THM 4L60-E/4L65-E "UPDATE HANDBOOK"

THM 4L60-E/4L65-E

THM 4L60-E TCC "PWM" SOLENOID ADDED IN 1995 AND NEW OIL PUMP ASSEMBLY FOR 1995

Figure 1

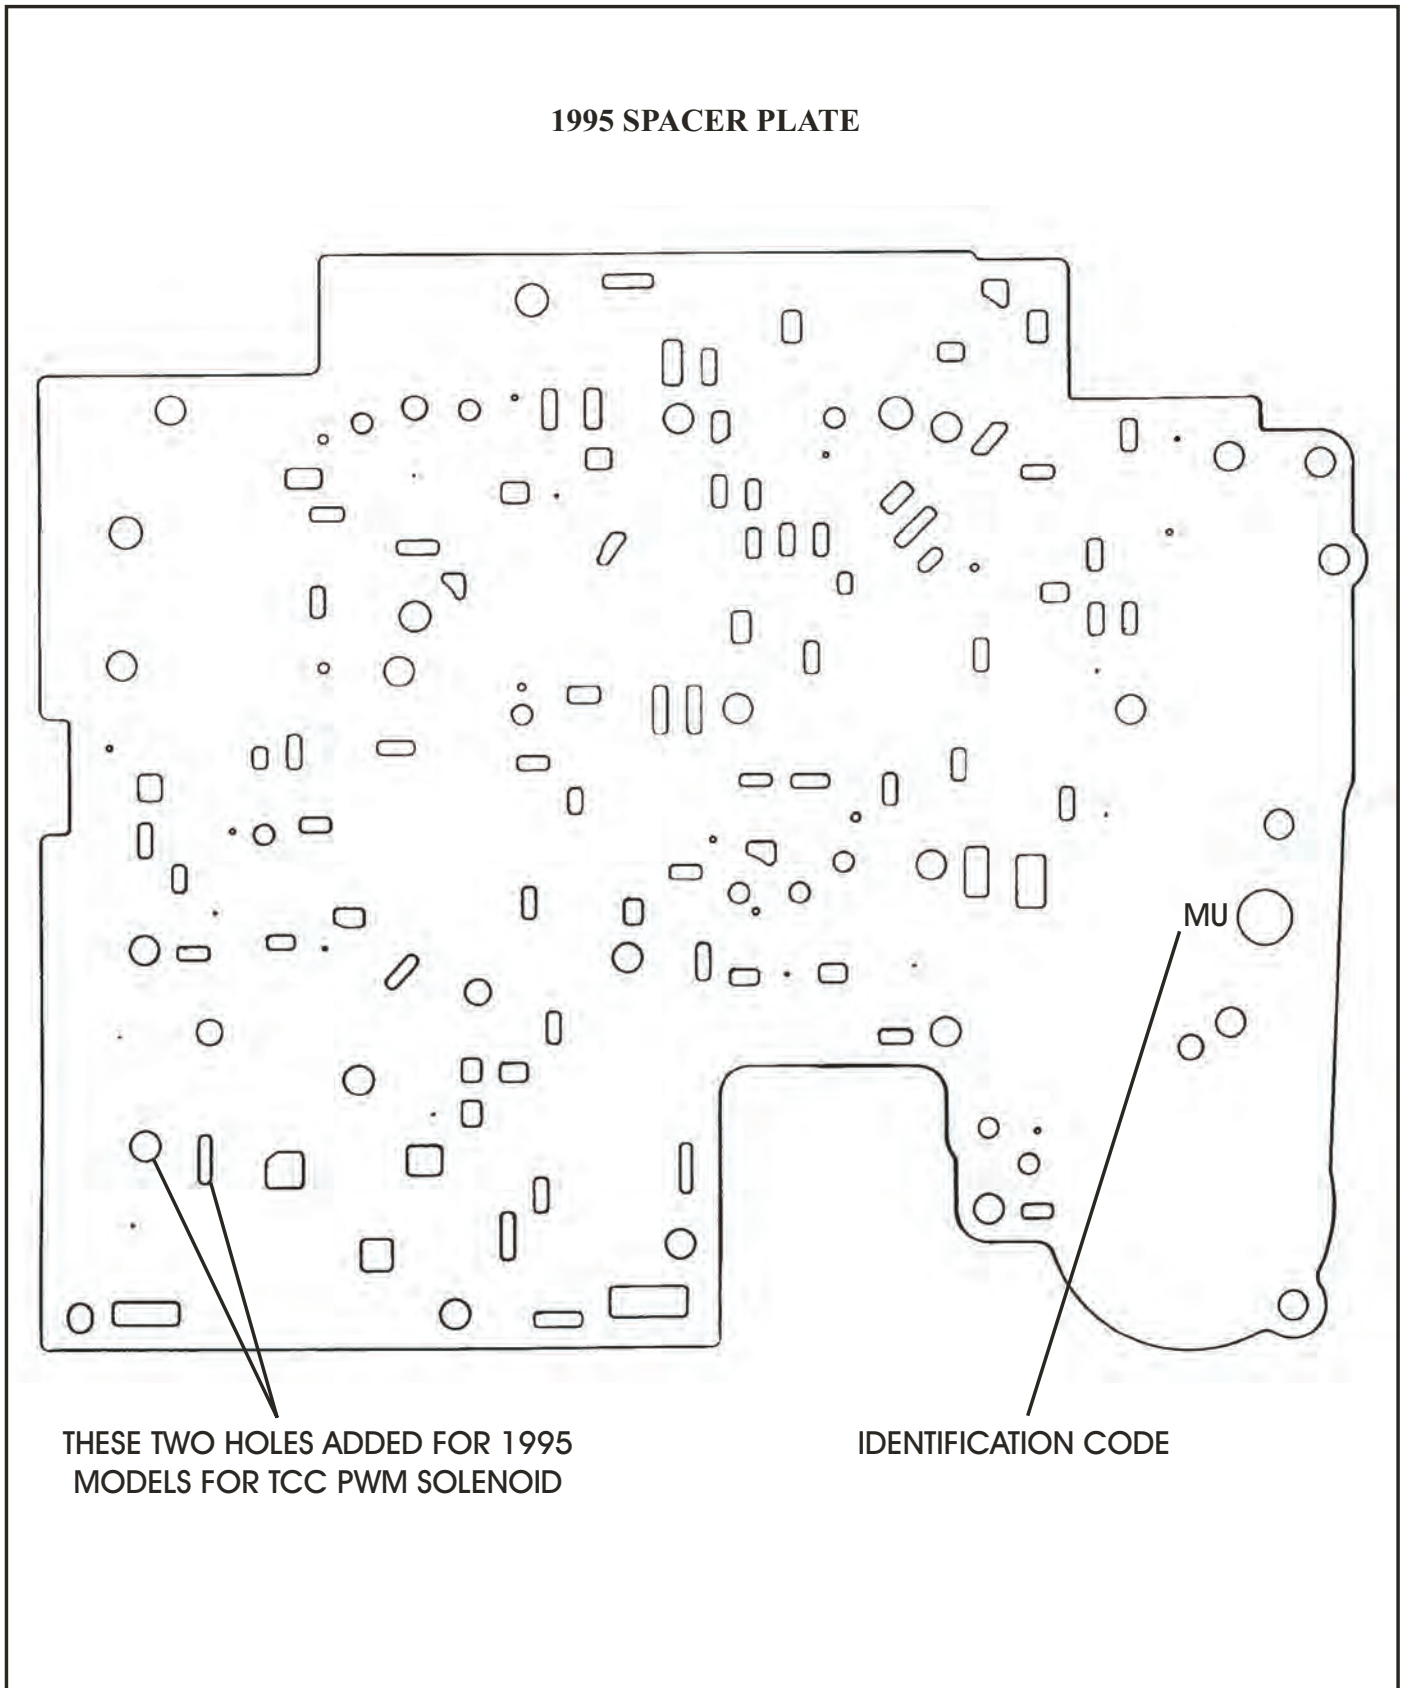
- (1) VALVE BODY CASTING - 1995 models are now machined to accept the added TCC PWM Solenoid, as shown in Figure 1. The added TCC PWM Solenoid is exactly the same and will interchange with the 3-2 downshift solenoid (See Figure 1).

Figure 2

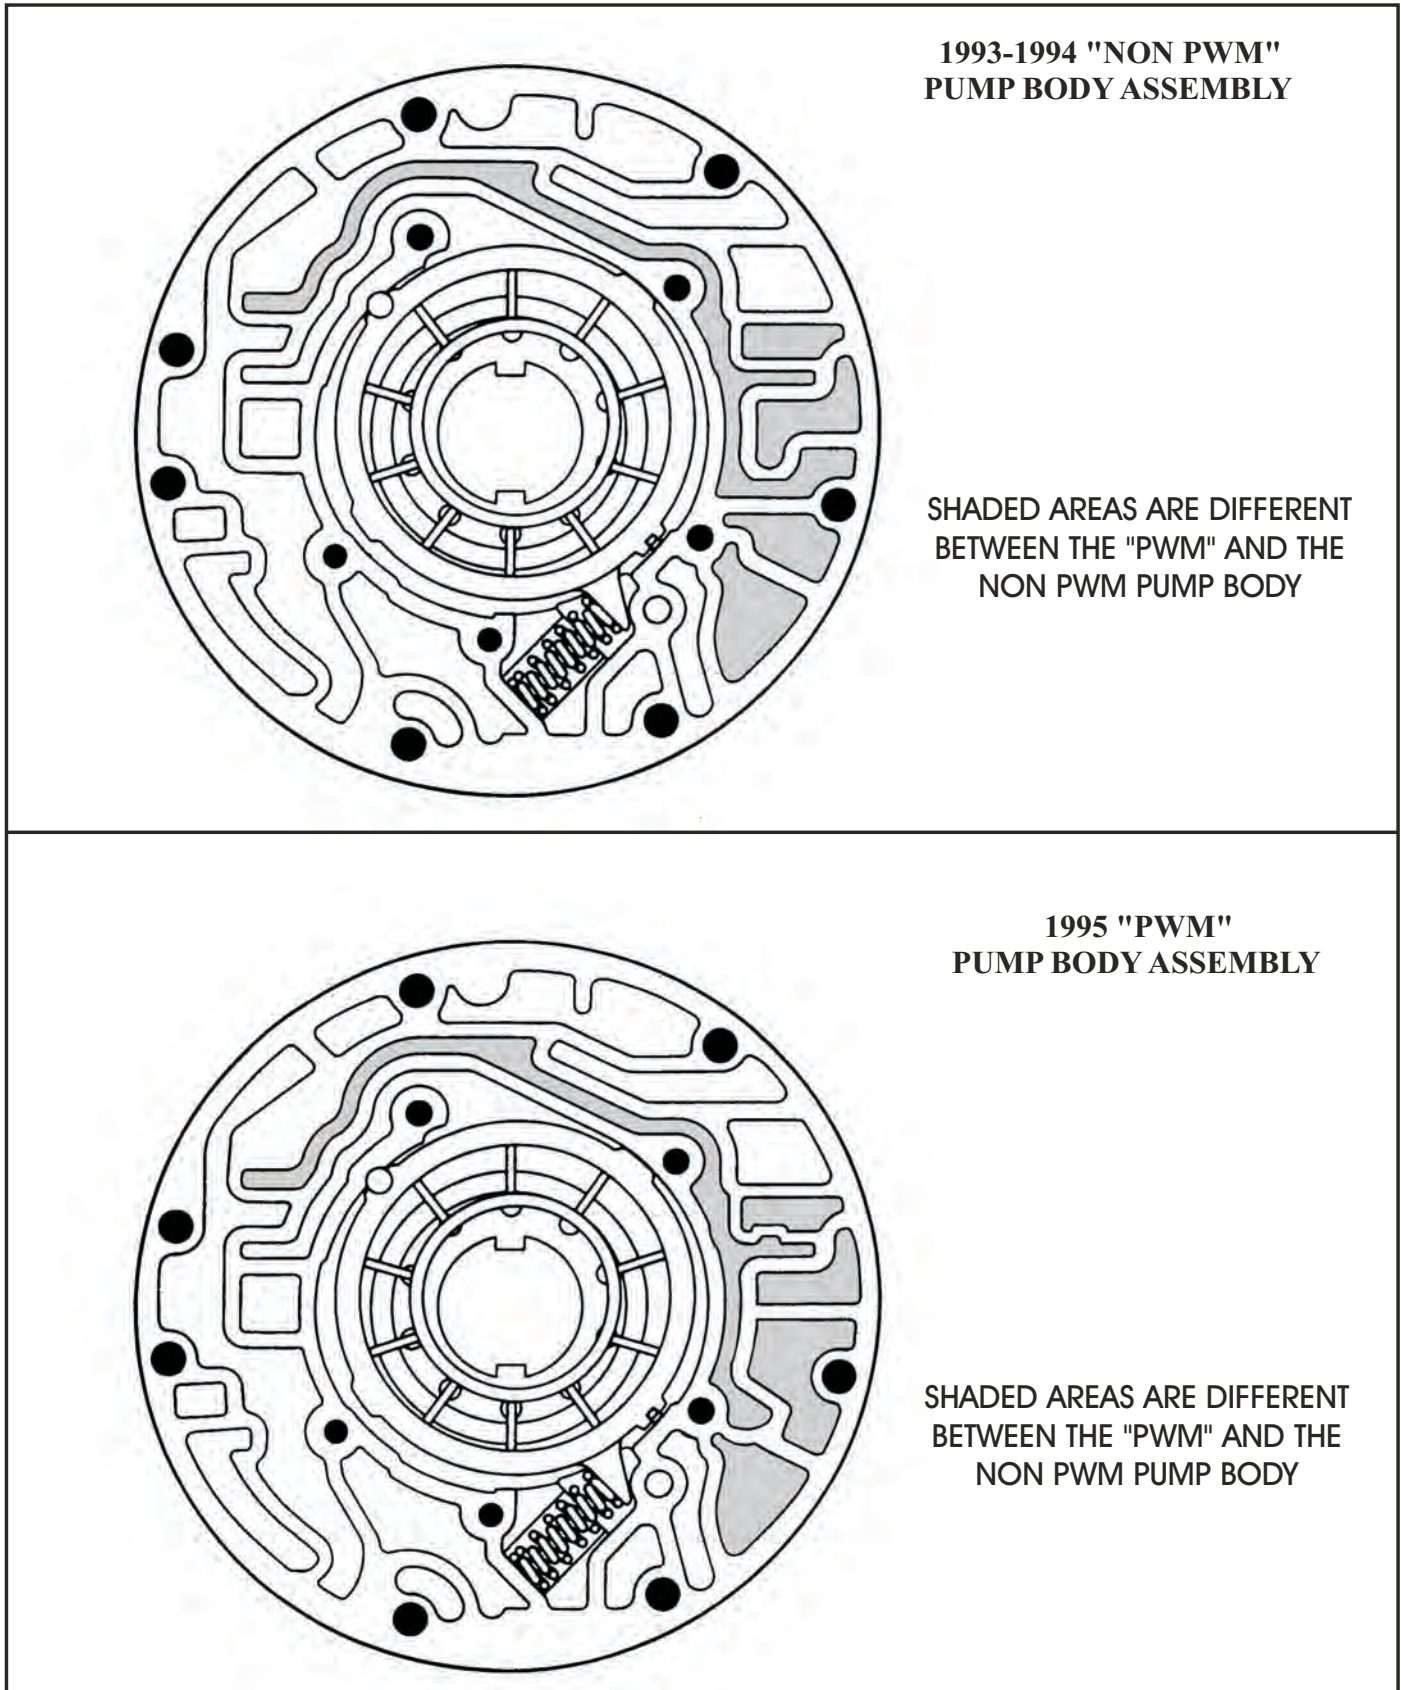
- (2) VALVE BODY SPACER PLATE - There were two holes added in the spacer plate to accommodate the added TCC PWM Solenoid as shown in Figure 2. The 1995 spacer plate can be identified with the first letter of the two digit code being either an "M" or "N", as shown in Figure 2. The first letter of the two digit code on the 1994 spacer plate will be "K" or "L". The 1993 spacer plate first letter will be "J". Refer to Figure 2 for location of the I.D. code stamped into the spacer plate

Figure 4

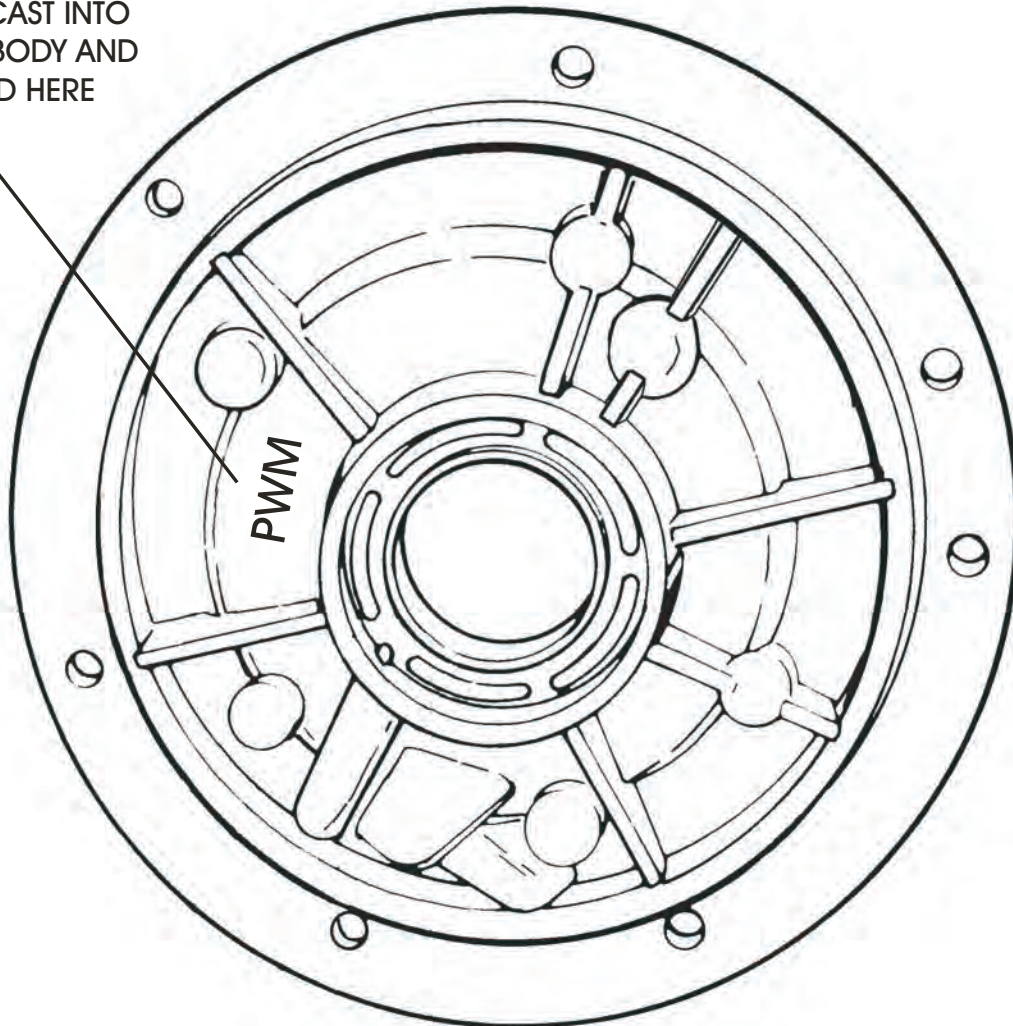
- (3) OIL PUMP BODY - There were changes in the worm track configuration on the new design pump body to accommodate the added TCC PWM solenoid. The pump body can be easily identified with "PWM" cast into the pump body, in the location shown in Figure 4. Refer to Figure 3 for the differences in the worm track area, which we have shaded for easy reference.

"PWM" IS CAST INTO
THE PUMP BODY AND
LOCATED HERE

Figure 6

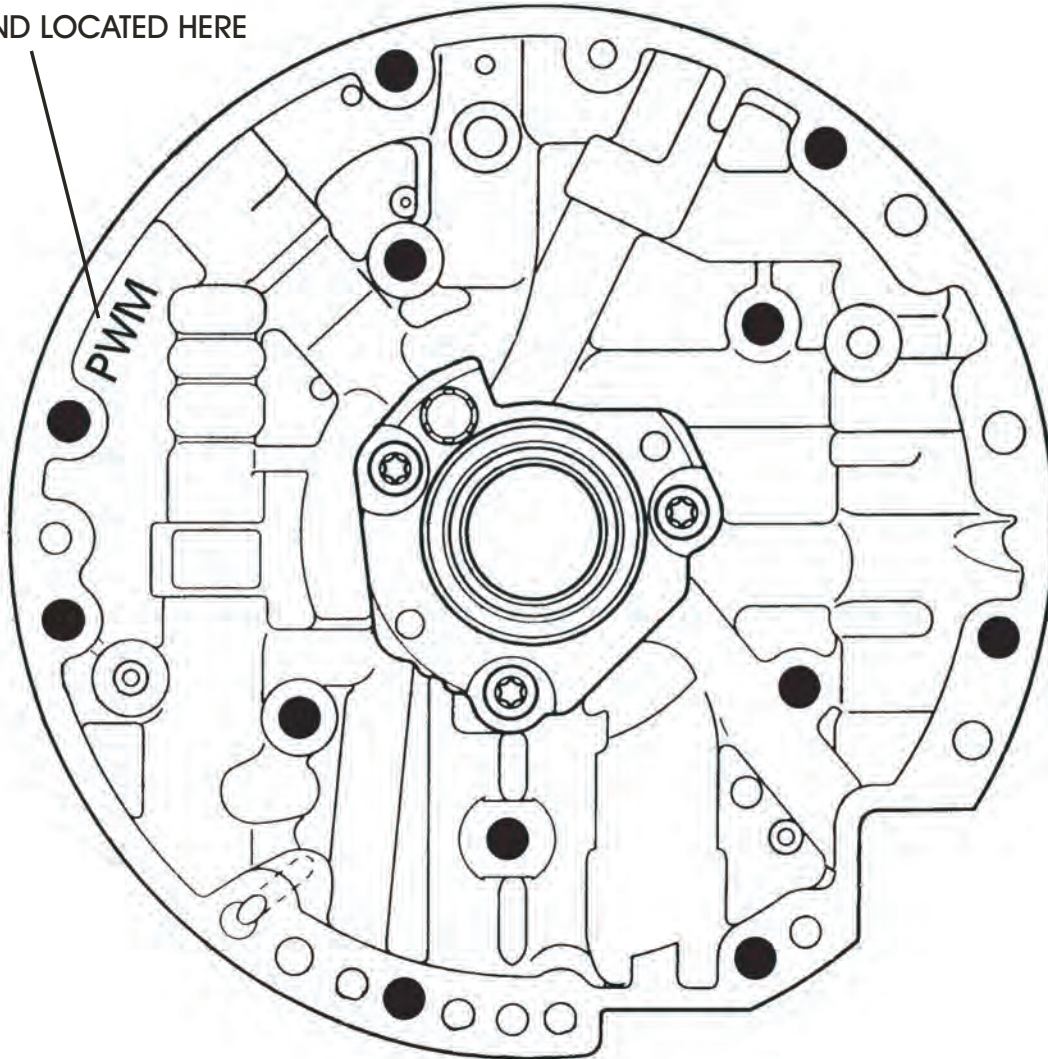
- (4) OIL PUMP COVER (STATOR) - There were changes in the worm track configuration on the new design pump cover to accommodate the added TCC PWM solenoid. The pump cover can be easily identified with "PWM" cast into the pump cover, in the location shown in Figure 6. Refer to Figure 5 for the differences in the worm track area, which we have shaded for easy reference.

"PWM" CAST INTO THE PUMP
COVER AND LOCATED HERE

Figure 1

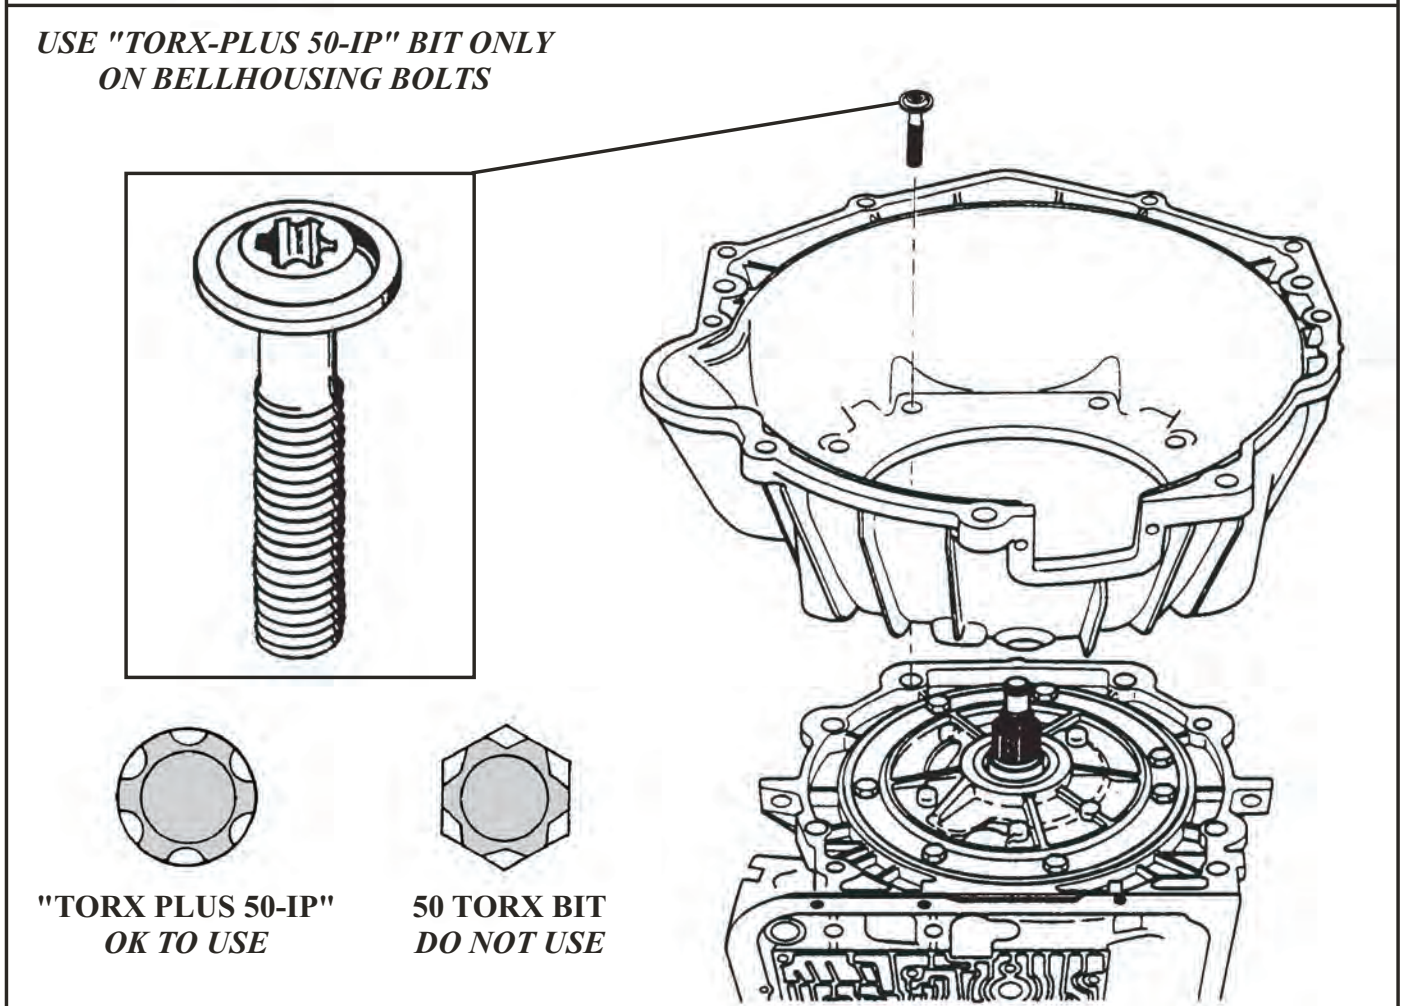
- (1) **BELLHOUSING** - Now bolted to the main case with eight bolts that require what appears to be a normal 50 Torx-bit to remove. *These bolts require a "TORX PLUS 50-IP" bit to remove.* The normal 50 Torx-bit will strip the head on most bellhousing bolts, if used for removal. Refer to Figure 1 for the profile of both bits.

- (2) **MAIN CASE** - Totally different casting to accommodate the bolt-on bellhousing, as shown in Figure 1. There were no changes in worm track configuration, or bolt hole locations for the bottom pan and valve body area.

- (3) **EXTENSION HOUSING** - Totally different casting to accommodate the changes in the case design, and notice the new design has six retaining bolts instead of the previous four, as shown in Figure 1.
